No. TC-1187

SUBJECT: CHD TC - Checking Hydraulic Oil Level

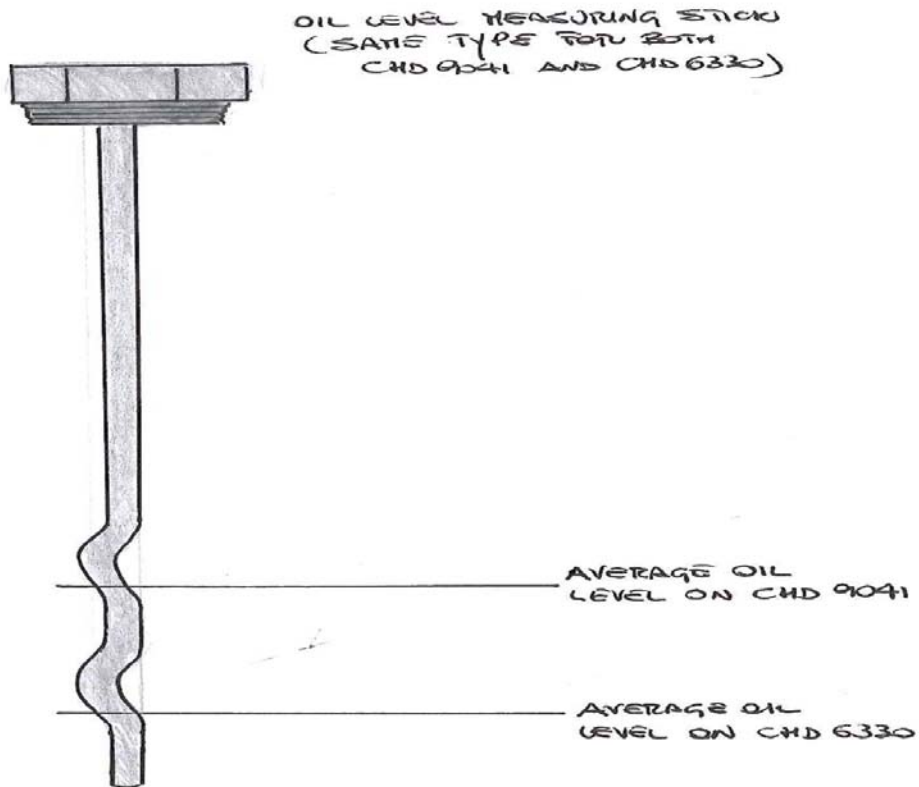
- It has come to our attention that the same dipstick is used on the CHD 6330, 9041, 9043, and 9051 models.
- Because the pump is not in the reservoir on the 6330, **the fill point level is lower on the 6330** than on the other models.
- **Remember when you are checking the oil level; all hydraulic cylinders must be fully retracted.**
- **The points shown in the following drawing are indicating the correct fill levels when the hydraulic oil is cold.**
